MEMORANDUM

PROJECT NAME: The Veneto
CASE #: 9-20060070
REVIEW TYPE: Project Plan

ZONE: CBD-1
APPLYING FOR: Approval for a maximum of 45,933 gross square feet of development, including 41,358 square feet of multi-family residential uses, a maximum of 20 units to include a minimum of three MPDUs, and 4,575 square feet of retail uses, on 0.294 acres

Parking Plan, with Site Boundary in Red

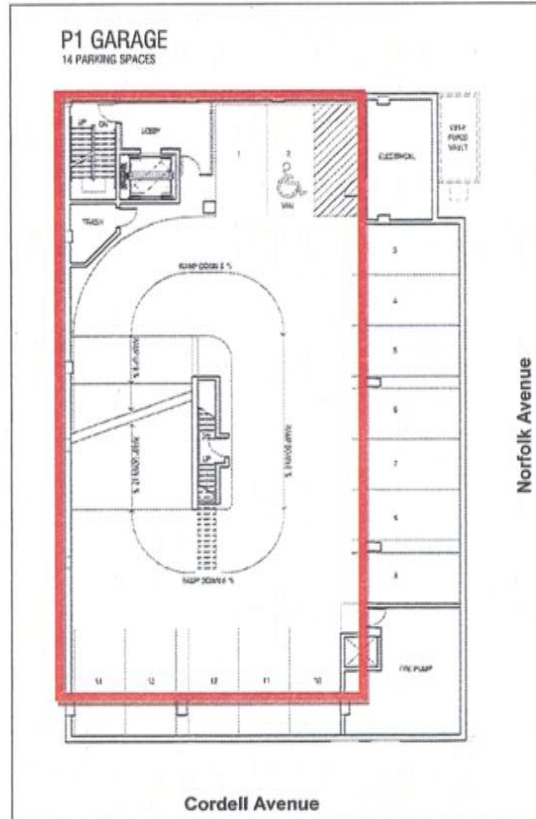
3. Parking Garage under the Building

This project is located within the Parking Lot Districts and is not required to provide on-site parking. However, as a market amenity, the Applicant is proposing to provide 30 on-site parking spaces underground in a structured garage. As proposed, the garage extends beyond the property line under the sidewalk into the Norfolk Avenue right-of-way. In their comments at the Development Review Committee, DPWT indicated they will not permit such private uses within the public right-of-way. While similar accommodation has been provided in other CBD locations, the public benefit of such an allowance on this site is insufficient for staff to recommend against DPWT's position. This issue will be resolved at Site Plan.

- a. DPWT approval of an alternative loading scenario that would not require a loading space within the building;
- b. DPWT approval for any intrusion of the underground parking garage into the Norfolk Avenue right-of-way.
